Product Change Notification

Product Change Notification: E-20-003530

AMPSEAL Sealed Connector System - Header Assembly

RECOMMENDED MOUNTING HOLE LAYOUT FOR 5.0 MAX THICK PANEL

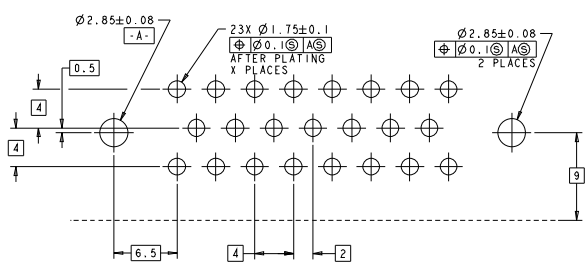
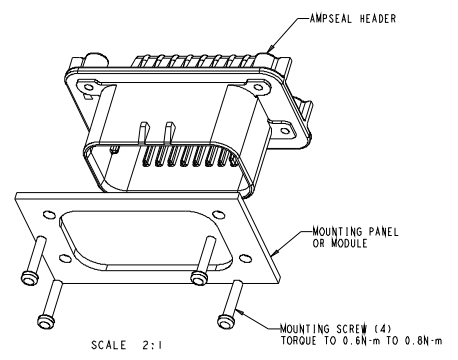
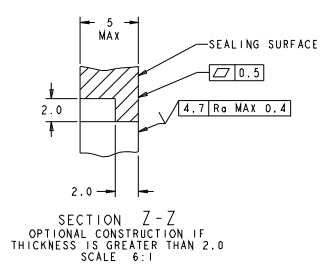
Customer Request. Dear Customer, we hereby inform you of this change. The change is necessary to clarify the information on mounting screw used on the AMPSEAL Header, to modify the mounting hole location dimensions from reference dimension to a tolerance dimension and the suggested mounting hole dimensions will be expanded to aid in the assembly of the header. The change does not impact performance. IMPORTANT: The current and previous revisions of these parts can be used interchangeably in the field.

- △ SUGGESTED MOUNTING SCREW SIZE IS $\varnothing 2.50-3.00$ mm ($\varnothing 0.099 - 0.118$ INCH) SELF TAPPING THREAD FORMING SCREW, SUCH AS DELTA PT., TO BE DRIVEN AT 0.6-0.8 N·m. THE CUSTOMER SHOULD TEST THE SCREW SIZE AND TYPE IN ORDER TO VERIFY THEIR SELECTION FOR THEIR APPLICATION.
 - △ DATE CODE TO BE BRANDED IN THIS LOCATION PER TE SPEC 102-60. USE 5 DIGIT CODE: FIRST 2 DIGITS = YEAR, SECOND 2 DIGITS = WEEK, LAST DIGIT = DAY.
 - △ HOUSING COLORS ARE MECHANICALLY KEYS TO MATE ONLY WITH IDENTICALLY COLORED PLUG ASSEMBLIES.
 - △ MATERIALS: HEADER HOUSING - GLASS FILLED PBT
PINS: TIN OR GOLD PLATED BRASS.
5. HEADER MATES TO PLUG ASSEMBLY 770680 WHICH USES REELED TERMINALS 770520 OR LOOSE PIECE TERMINALS 770854.
